ADDENDUM #04

DATE:	September 29, 2023	PROJECT NO.:	Project # 20229080 CRSA Project # 21-031
TO:	Gramoll Construction 155 S. 750 W. North Salt Lake, UT 84054	PROJECT:	Rio Grande Depot Seismic 300 S. Rio Grande St. SLC, UT 84101

This Addendum forms a part of the Contract Documents and modifies the original Bid Documents dated October 3, 2022 as noted below. Acknowledge receipt of this Addendum in the space provided on the Bid Form. Failure to do so may subject the Bidder to disqualification.

B3 ALTERNATING FOUNDATION STRENGTHENING DETAIL
SB502 NO SCALE

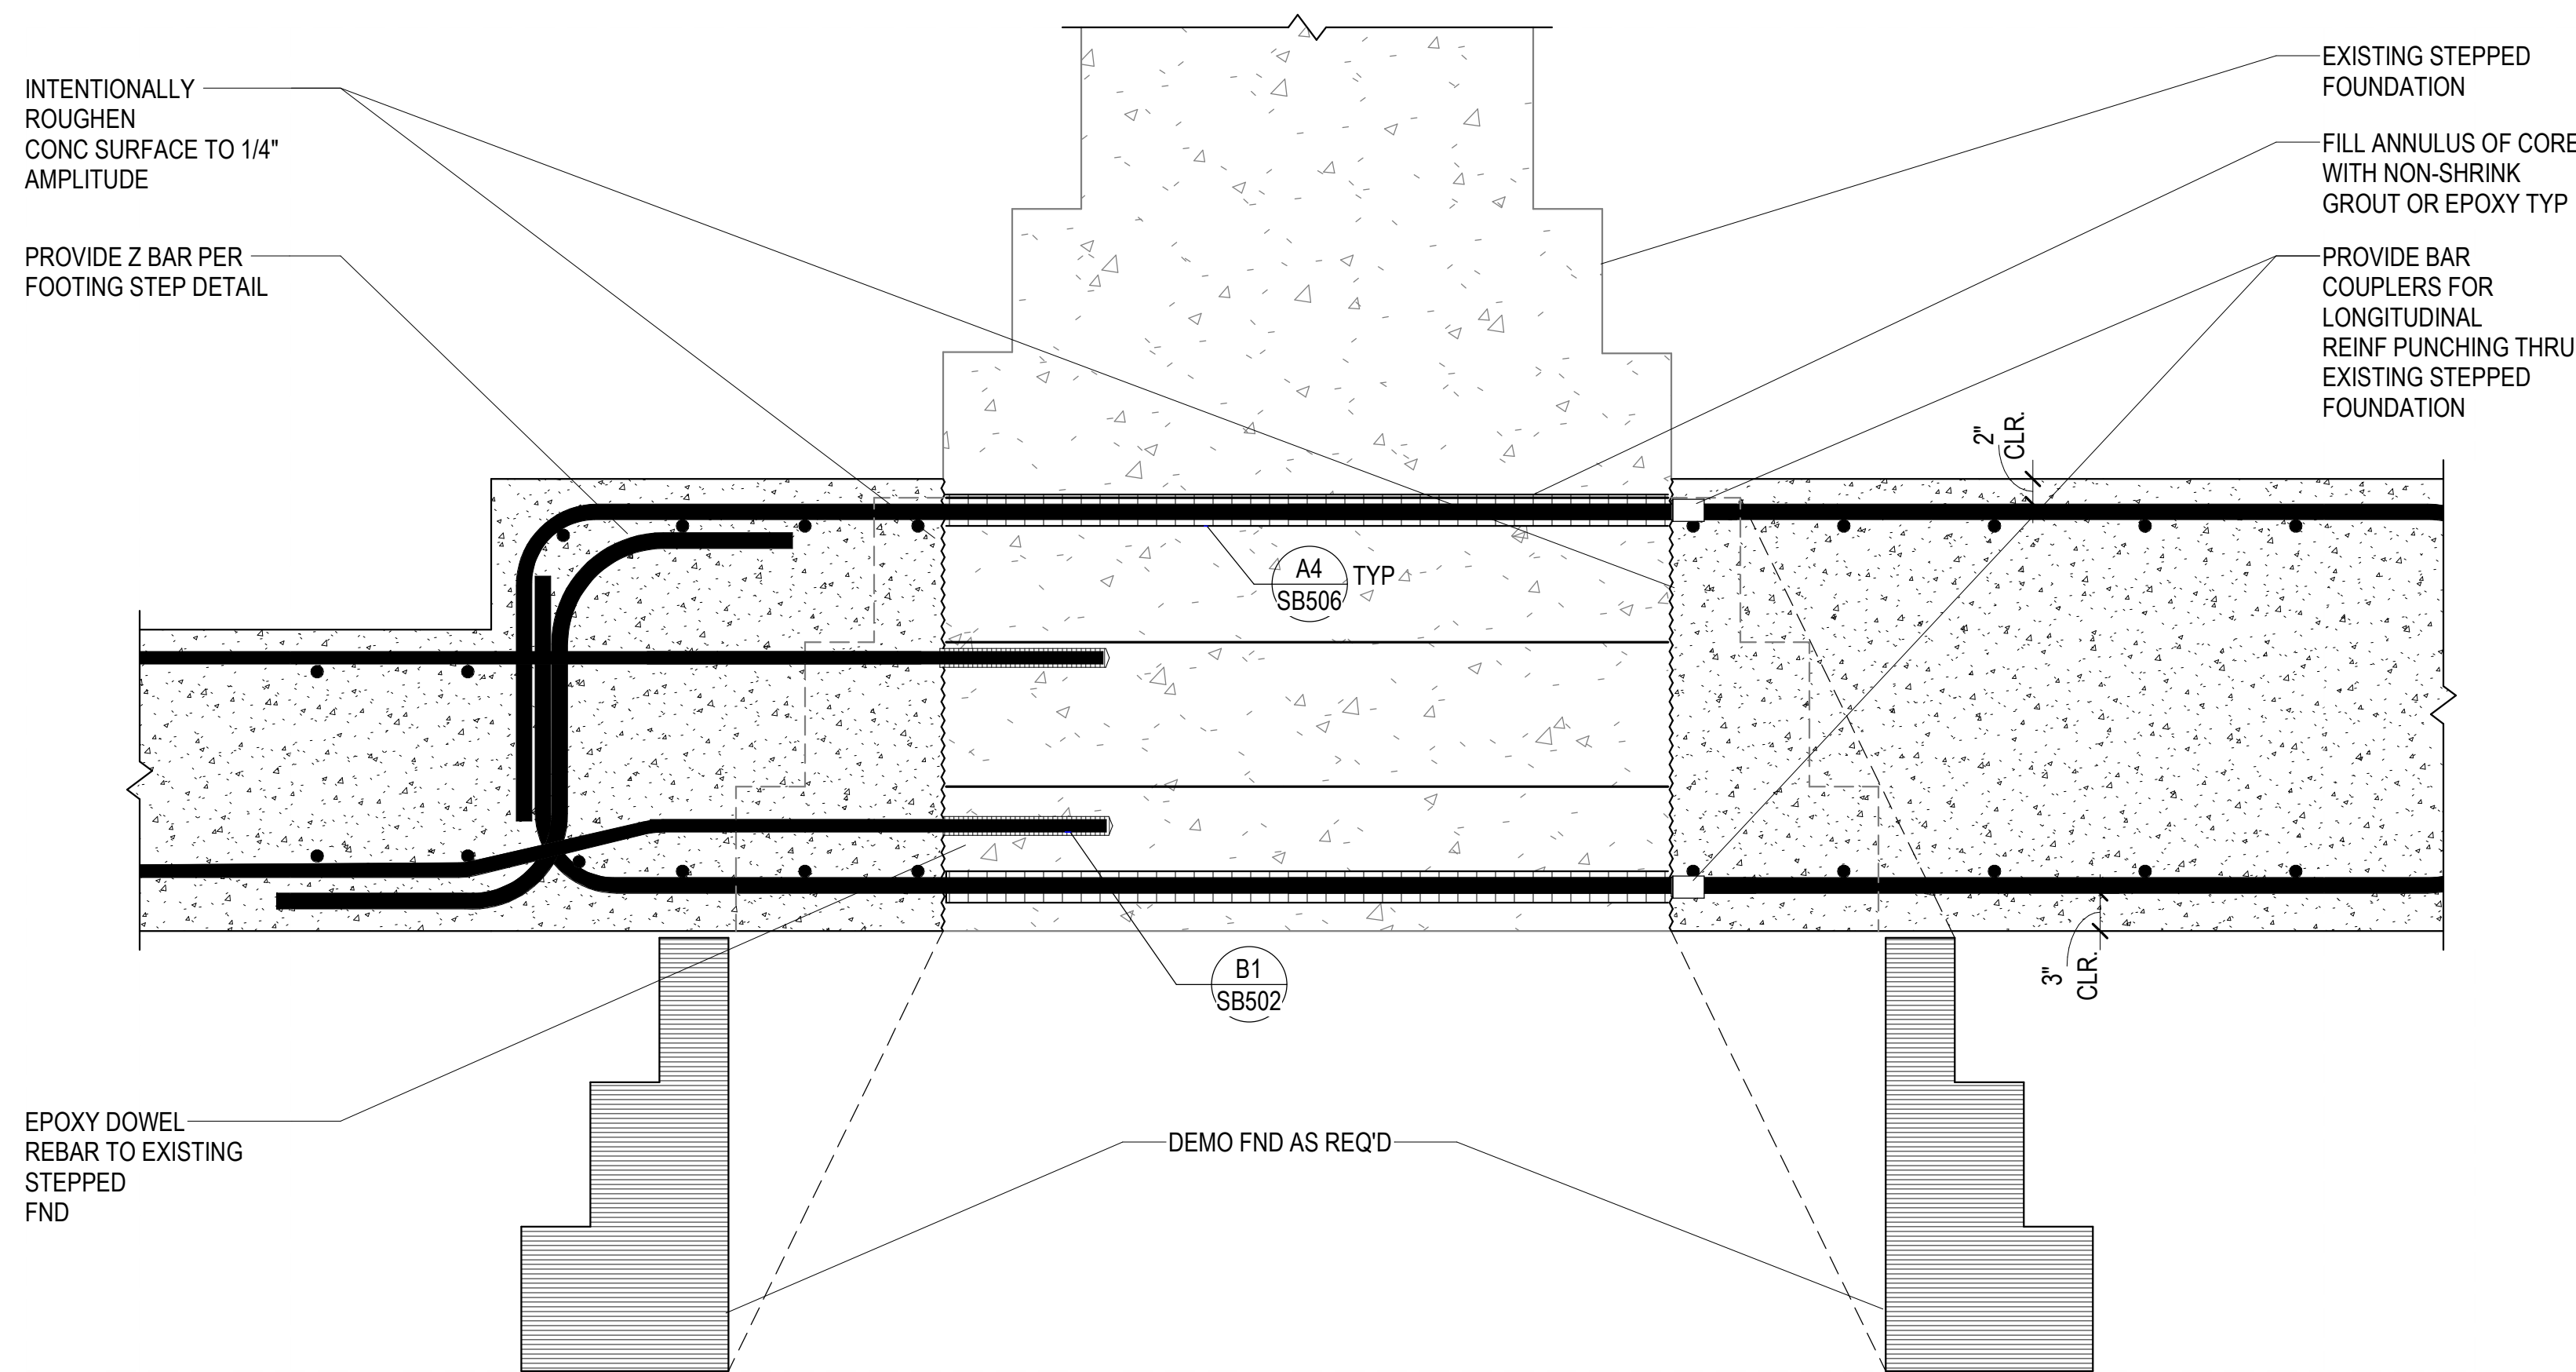
- IX-6 Question: Is there a vapor barrier required under the basement SOG?
a) Answer: Yes, per detail C1/AE511. - CRSA
- IX-7 Question: On sheet SB 502 detail B3 states that the construction sequence requires concrete to meet design strength for demo and pour of alternate segments. It also states that demo and pour of alternating sections after 28 days cure. Which requirement takes precedence, concrete strengths or 28 days?

- IX-26 Question: Most of the footing details that indicate a portion of the existing to be removed say "demo as required." Two of the details say, "Remove a portion of existing footing" (C2/SB502, B4/SB503). Are these 2 details the only details where detail B3/SB502 (Alternating Foundation Strengthening) applies?

a) Answer: Wording has been clarified in addendum. - Reaveley
- IX-8 Question: On sheet SB 502 detail C2 indicates roughen surface of the footing pours. Is it the engineer's intent to roughen all of the surfaces that the footings and walls pour against existing concrete surfaces or just the footings?

- a) Answer: Detail B3/SB502 applies to both basements of the wings, areas A and C. - Reaveley
- IX-27 Question: What is the purpose of the new concrete wall jumping from 10" thick to 24" thick at level 96'-0"? Can this possibly be 10" to 18" or even possibly less?
